ADDENDUM NUMBER 1

Issued: July 12, 2011

SERVICE CENTER RELOCATION
(2025 AVIATION BOULEVARD)

FROM: Sonoma County Water Agency
404 Aviation Blvd.
Santa Rosa, CA 95403-9019

SCALE: AS SHOWN DATE: 06-06-11	SERVICE CENTER RELOCATION (2025 AVIATION BOULEVARD) GRADING PLAN	
DRAWN: SMP REVIEWED:		FILE NAME: 7449_Site_Addendum1.dwg CONTRACT NUMBER: 0-706-7 #01		DRAWING NUMBER: C-3 SHEET 5 OF 64
NO. 1 DATE: 07-12-11 ADDENDUM No.1	REVISION	BY

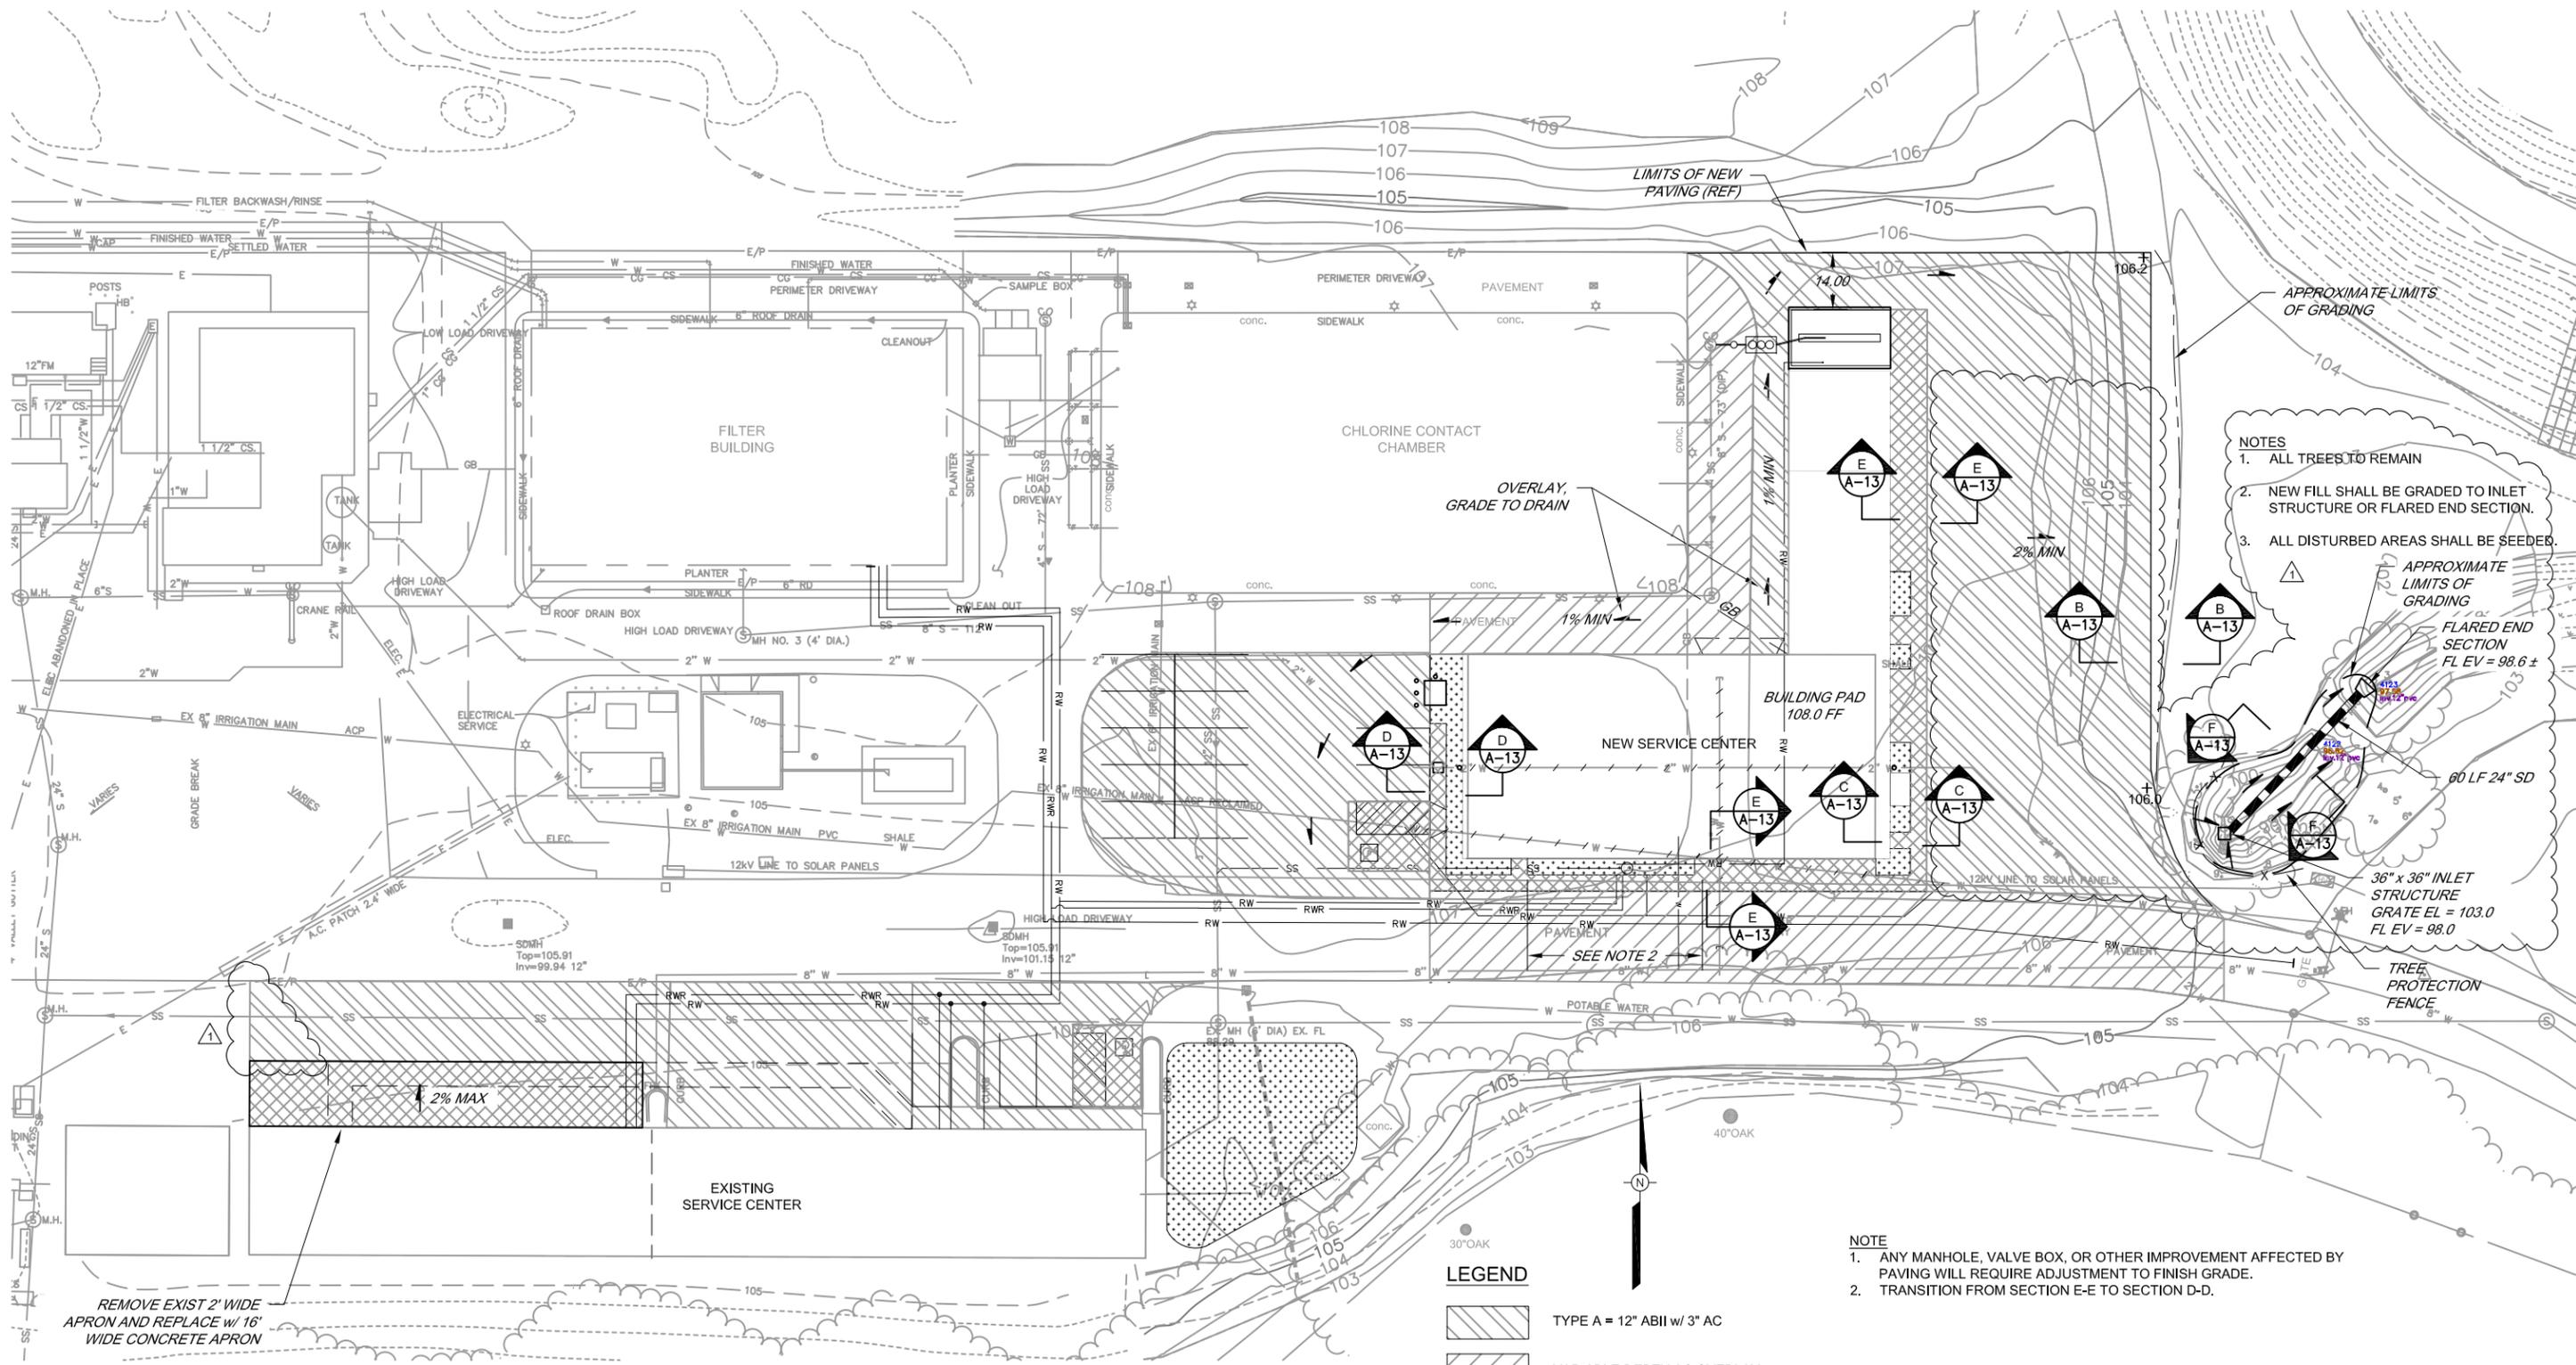
- B. Delete Drawing Number C-3 and replace with attached Drawing Number C-3, marked "7/12/11 Addendum No. 1."
- C. Delete Drawing Number A-3 and replace with attached Drawing Number A-3, marked "7/12/11 Addendum No. 1."
- D. Modify label between reference lines 2 and 3 on Drawing Number A-4 as follows:
19'-6" x 15' x 8' H CLEAR MEZZANINE w/90° RETURN STAIRWAY (TYP)
- E. Delete Drawing Number A-13 and replace with attached Drawing Number A-13, marked "7/12/11 Addendum No. 1."
- F. Add the following as Note 3 on Drawing Number P-1 as follows:
3. Provide tee and ball valve in irrigation valve box for future irrigation. Exact location to be as directed by Owner.
- G. Modify label between reference lines 9 and 10 on Drawing Number M2.10 as follows:
REMOVE EXISTING HEAT PUMP AND REPLACE WITH HP4

REMOVE EXIST 2' WIDE APRON AND REPLACE W/ 16' WIDE CONCRETE APRON
